6 Series Villa Door Stations
Version: V2.2.55_build220816
Release Note
(2022-08-16)

Firmware Basic Information	Firmware Version	V2.2.55_build220816
	Device Type	DS-KV6113-WPE1(C) DS-KV6113-PE1(C) DS-KV6103-PE1(C)

6 Series Villa Door Stations
Version: V2.2.55_build220419
Release Note
(2022-04-19)

2.2 Day/Night mode configuration on WEB

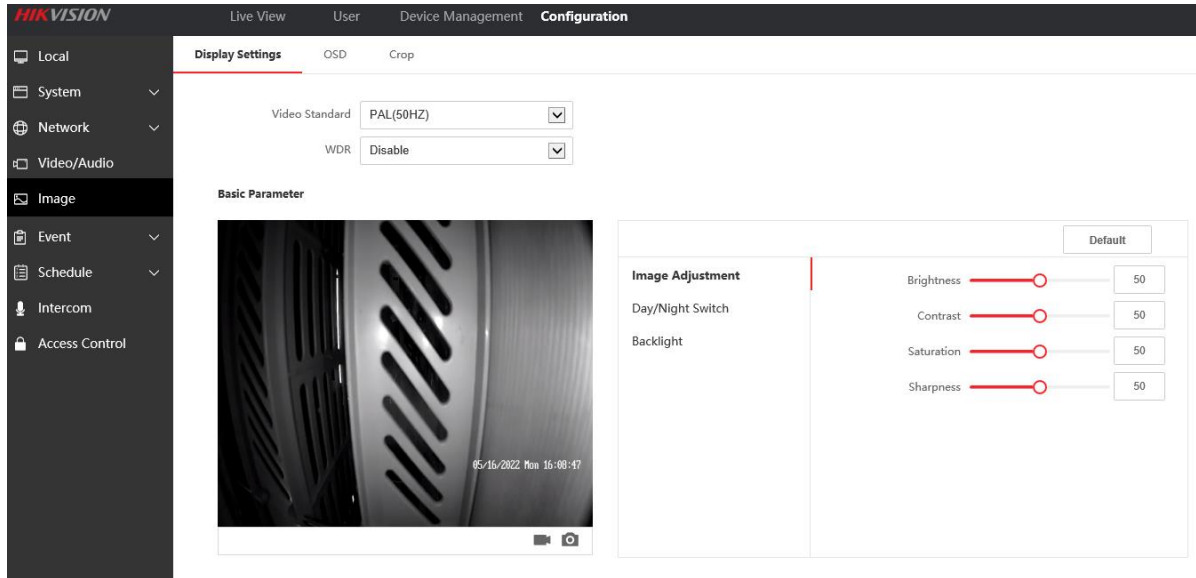
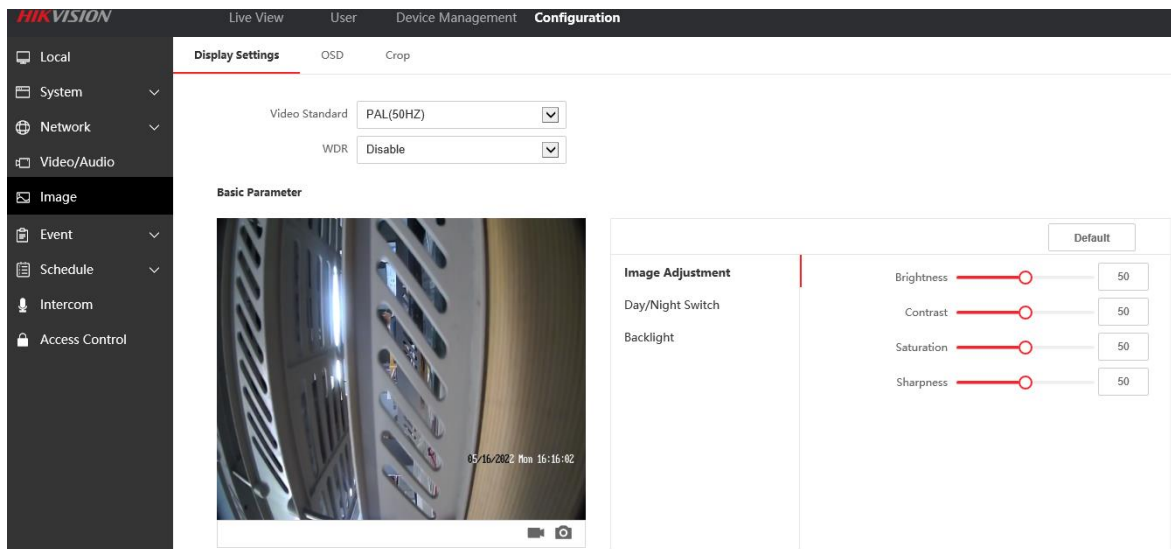
In [Night] mode, the image setting is invalid.

Image Adjustment including [Contrast], [Saturation], [Sharpness] are all invalid.

In [Day mode], the image setting would be enabled.
Image Adjustment including [Brightness], [Contrast], [Saturation], [Sharpness] are all enable.

2.3 Ringbacktone in French

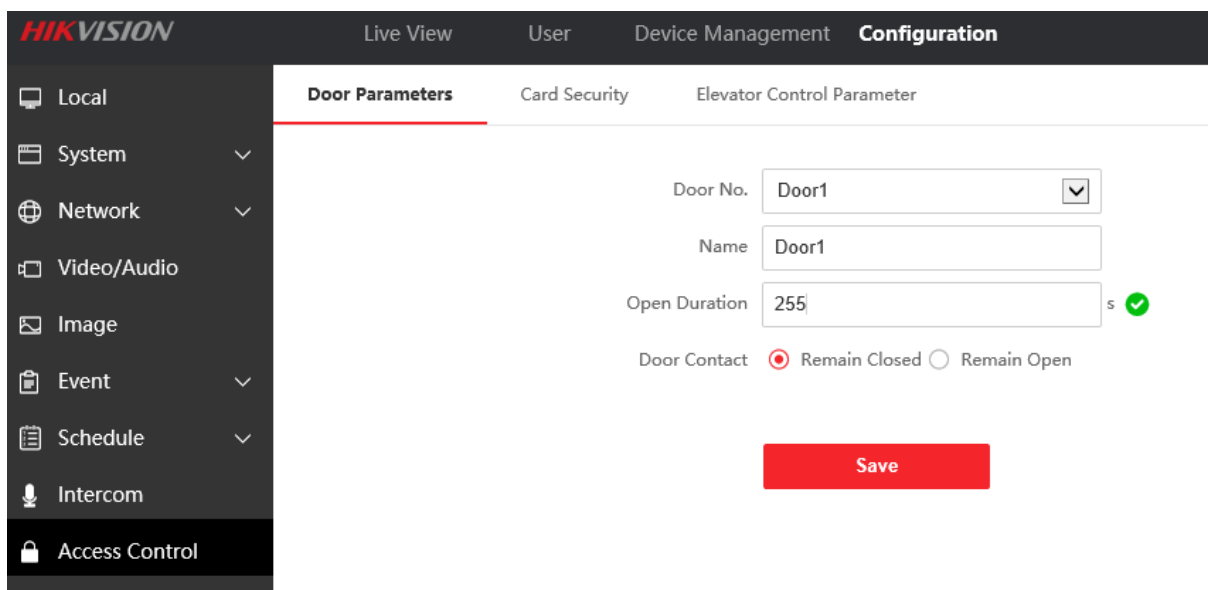
The prompt voice “appel en course” means “Calling” when pressing the call button.

The prompt voice “en communication”, means “on a call”.

The prompt voice “la Porte est ouvert”, means “The door is open”
